**Authority:** North Yorkshire Council (former area of Selby District Council)

**Full details of application/consultation** 2023/0128/EIA - Development of a ground-mounted solar farm including associated infrastructure

**At land at:** South Of A645, Wade House Lane, Drax, Selby, North Yorkshire

**Type of response:** Objection

Fig. 1 – colour blocks denote extent of approved (grey), current proposal (purple) and forthcoming DCO scheme (red) surrounding local villages

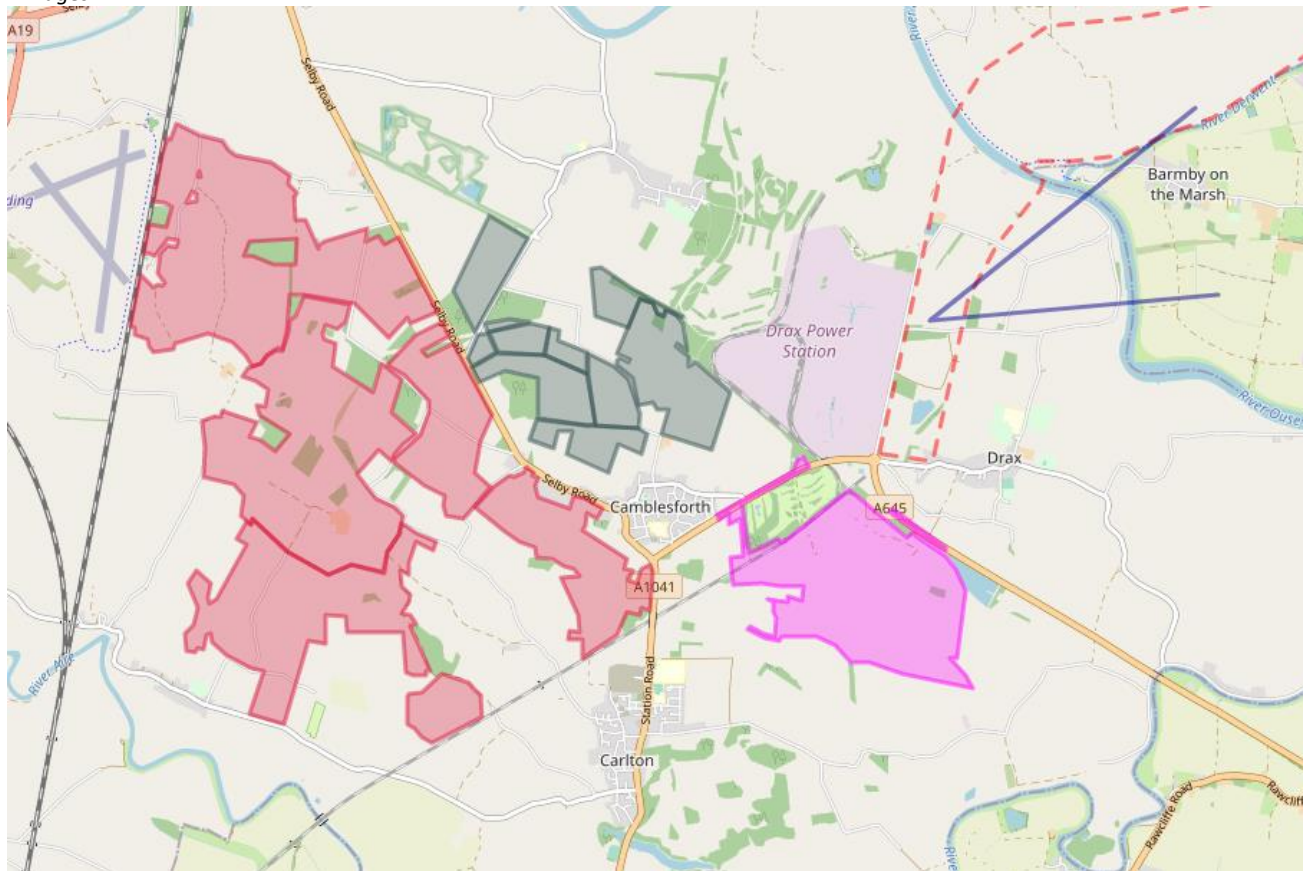
It is clear that the residents of the parishes will be surrounded by renewable energy schemes and within close proximity to Drax Power Station as illustrated by figure 1 below. Whilst it could be considered that solar (and renewable) schemes can be considered to be more favourable to a fossil fuel using power generation plant, for the residents, they will truly be surrounded. The Soar Arrays are all of such vase size in their own right and when considered to be at a height of some 4.5m above ground level are not low-laying by any means. Residential amenity is understandably a concern. Should they wish to use the PRoW network, they will be faced with construction noise and dust and highways concerns, further a detrimental visual impact. Once in the operational stage, residents, if feeling that they wish to attempt the PRoW network will have to contend with a feeling of being enclosed throughout the considerable site by the large scale solar arrays. For those with mobility concerns, the new network of paths are located at the furthest point away from the existing dwellings making it much more difficult for them to access the open

Whilst it is acknowledged the Council can only consider applications based on their own merits, the cumulative impact of other such proposals in the local vicinity should also be taken into consideration in the planning balance when determining a proposal as directed by the NPPF.
